# **ADDENDUM NUMBER: ONE [1]**

PROJECT: Provalus Whiteville

DATE: November 20, 2024

Drawings and Project Manual dated <u>October 30, 2024</u>, for this project are hereby modified, corrected, or supplemented as follows:

ELECTRICAL NOTES, LEGEND, DETAIL

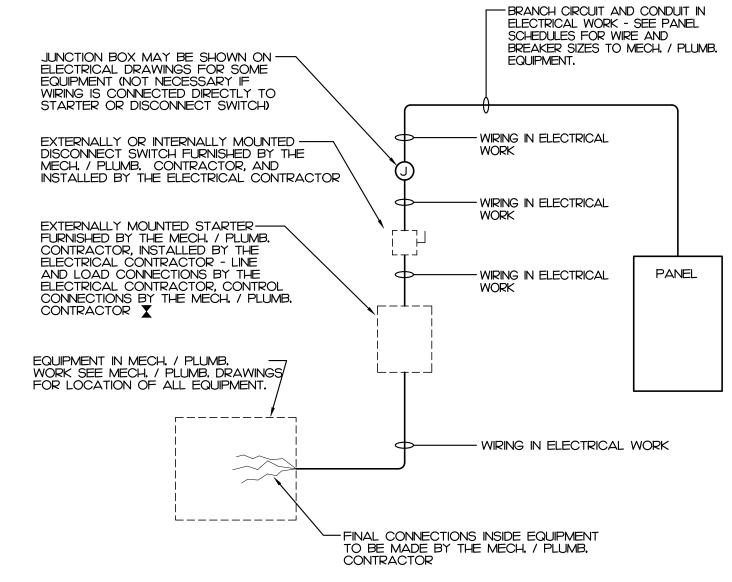
Item <u>11</u> Revision Sheet E0.1 – Electrical Notes, Legend, Details

General Note updates

Sheet Title
COVERSHEET

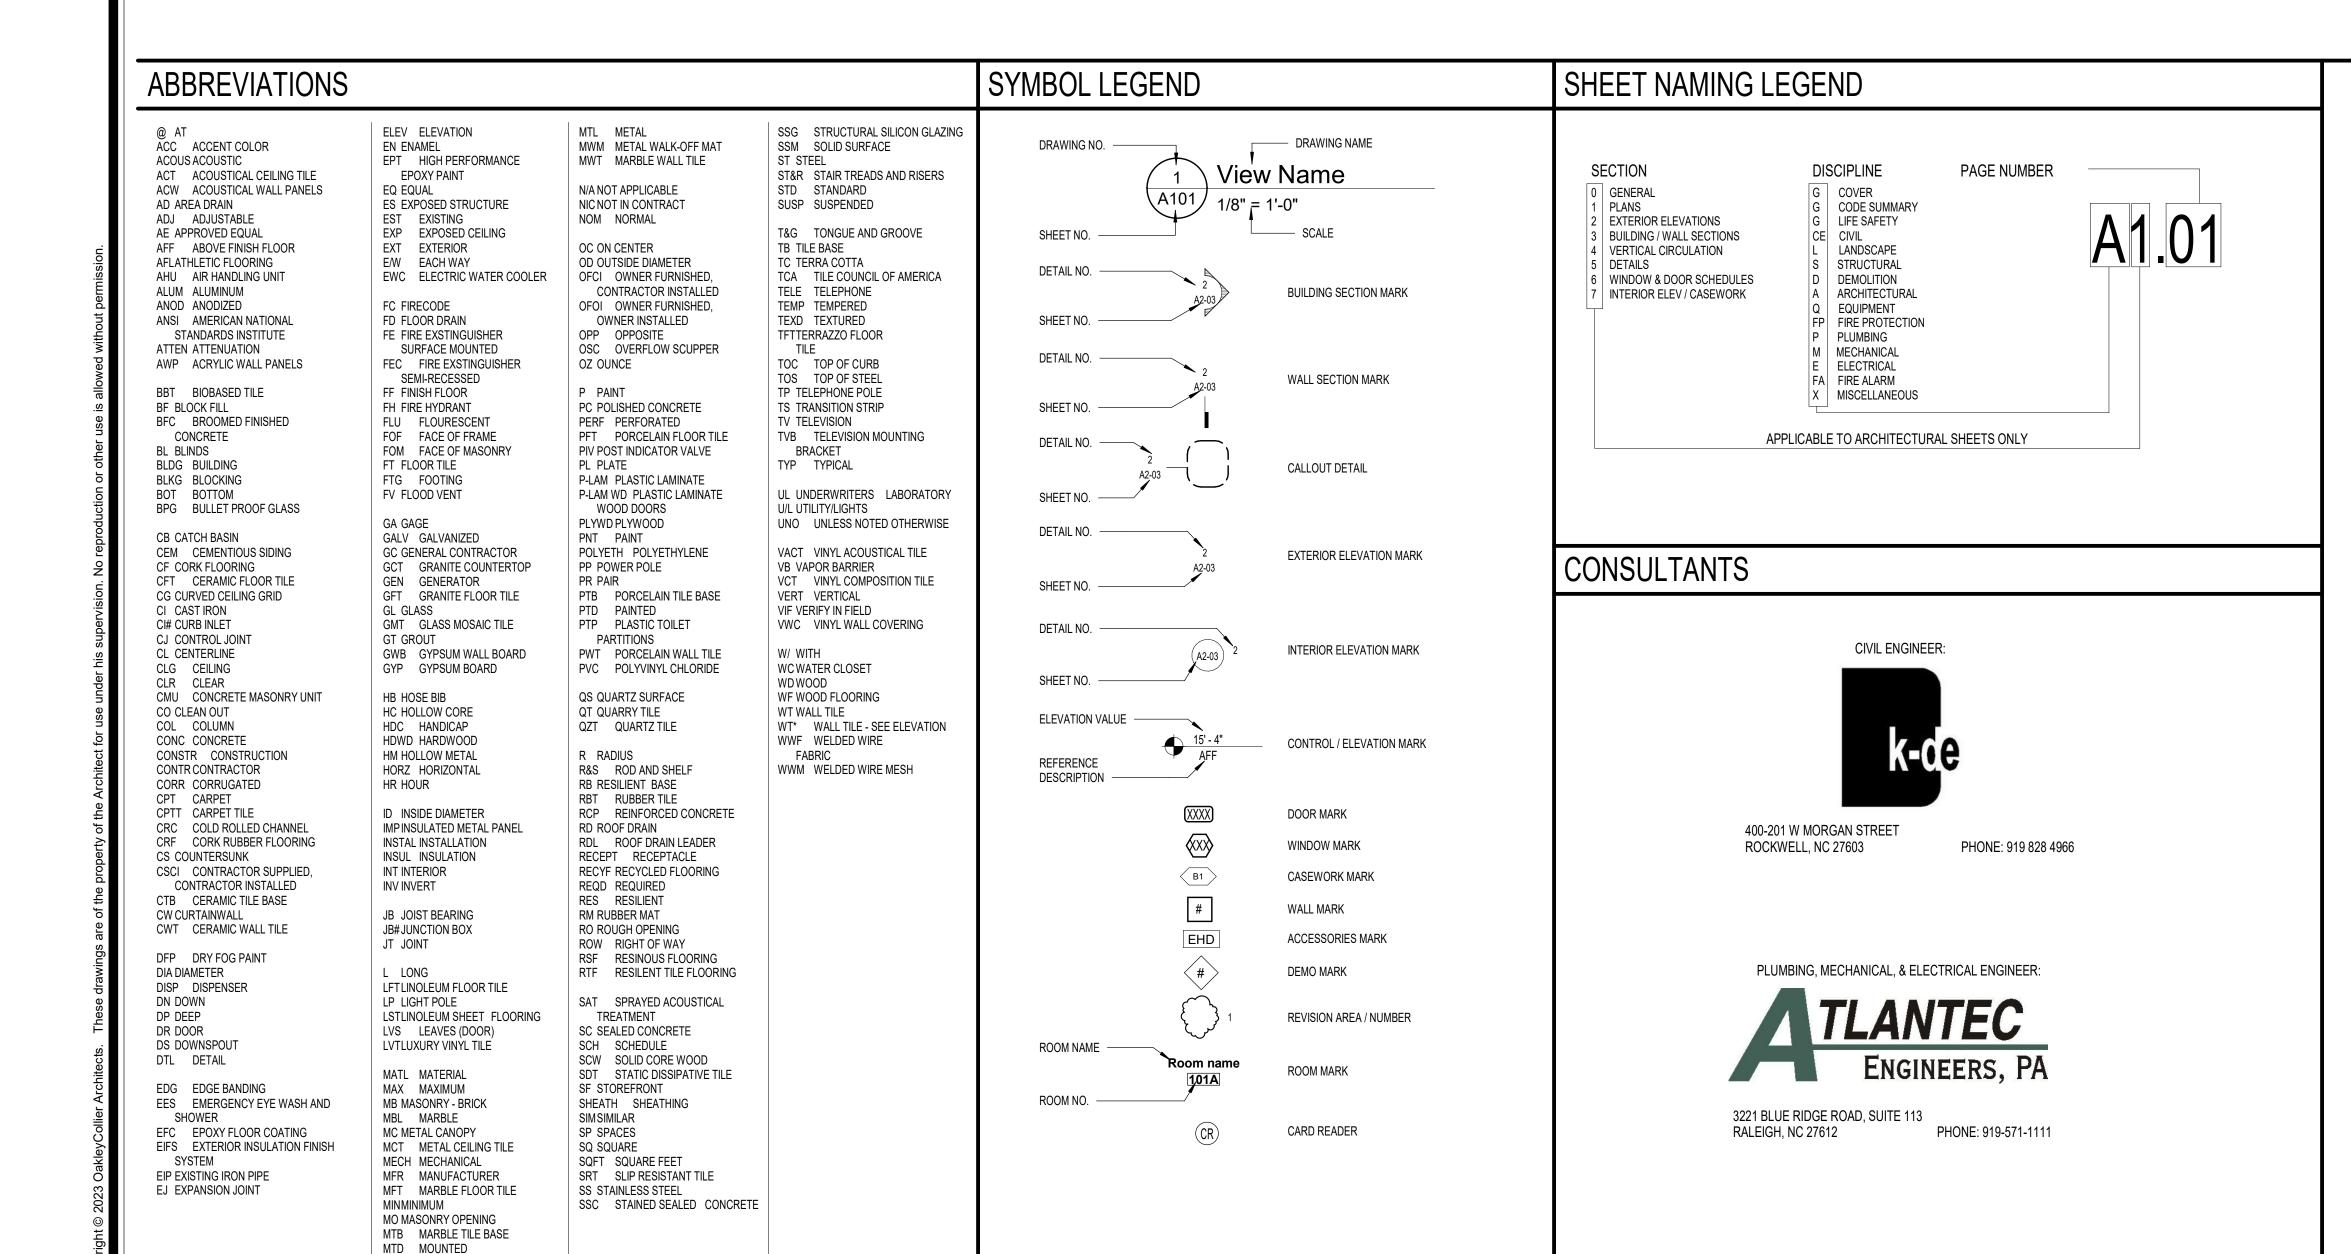
Item <u>3</u> Revision Sheet G0.1 – Coversheet

Index of Drawings updated to omit not-used sheets (D1.3 and A7.1)

LIFE SAFETY

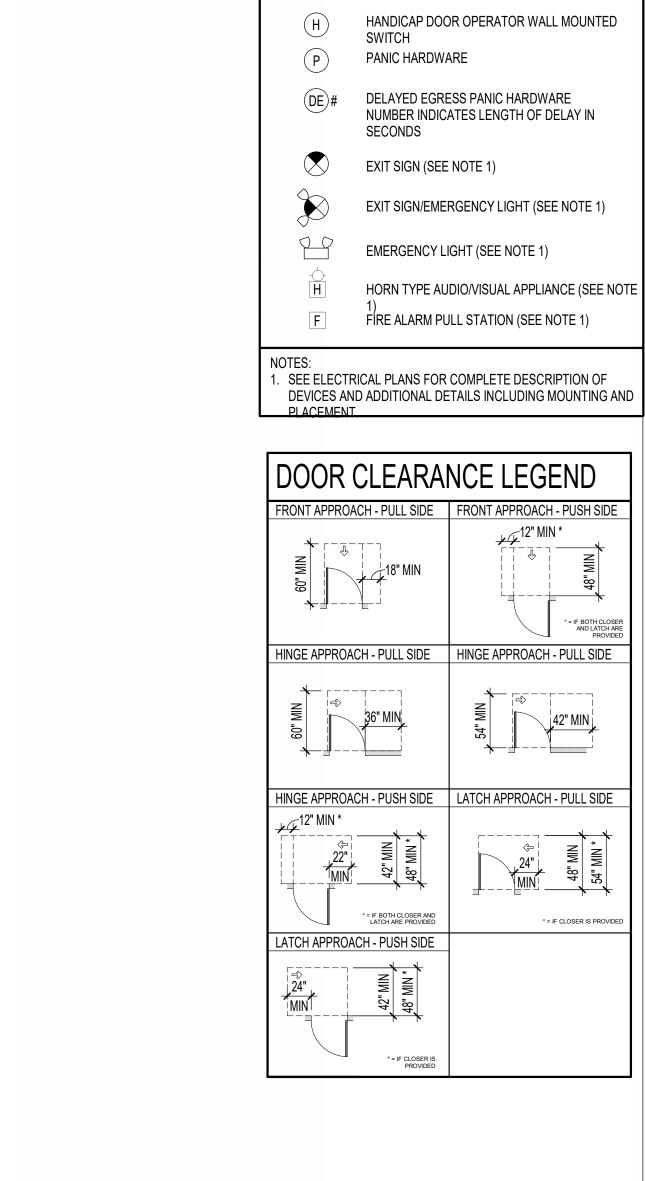
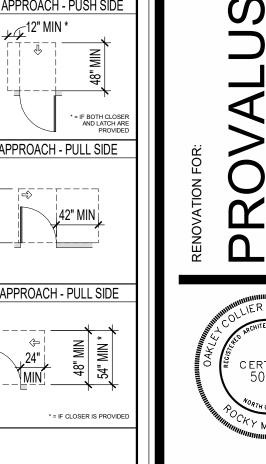
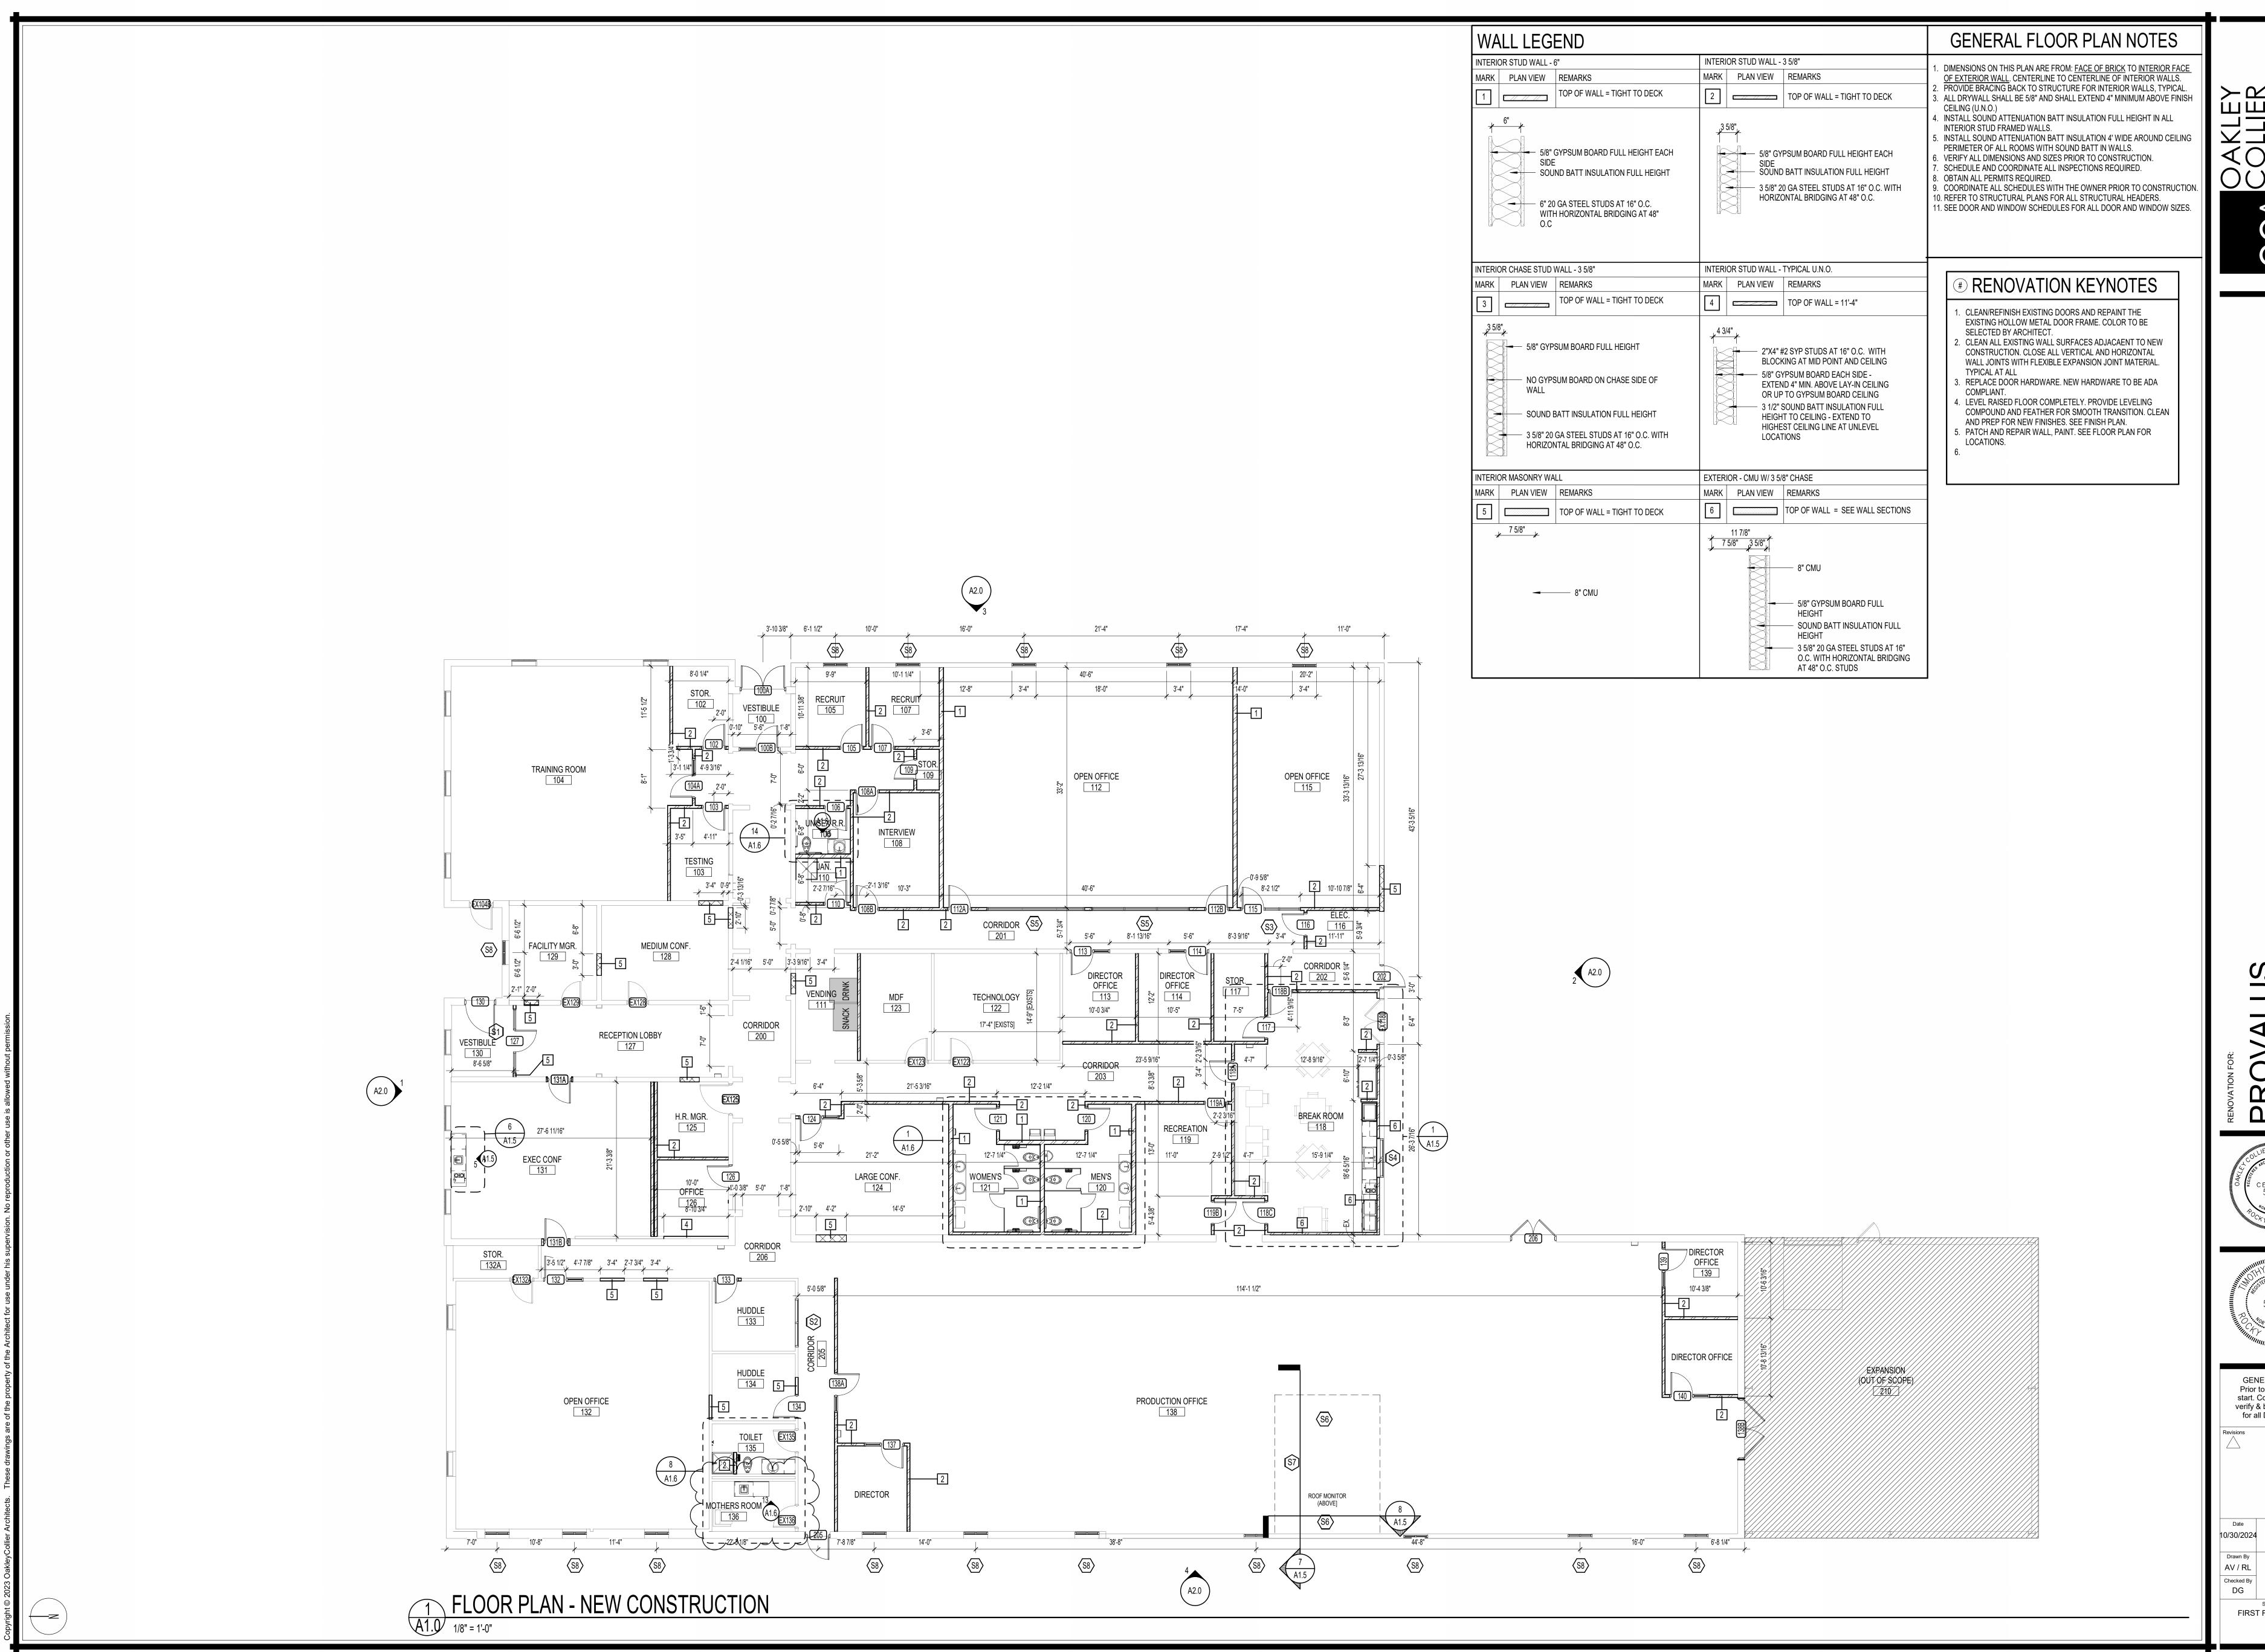
Item <u>4</u> Revision Sheet G1.0 – Life Safety

Updated exit separation distance dimension
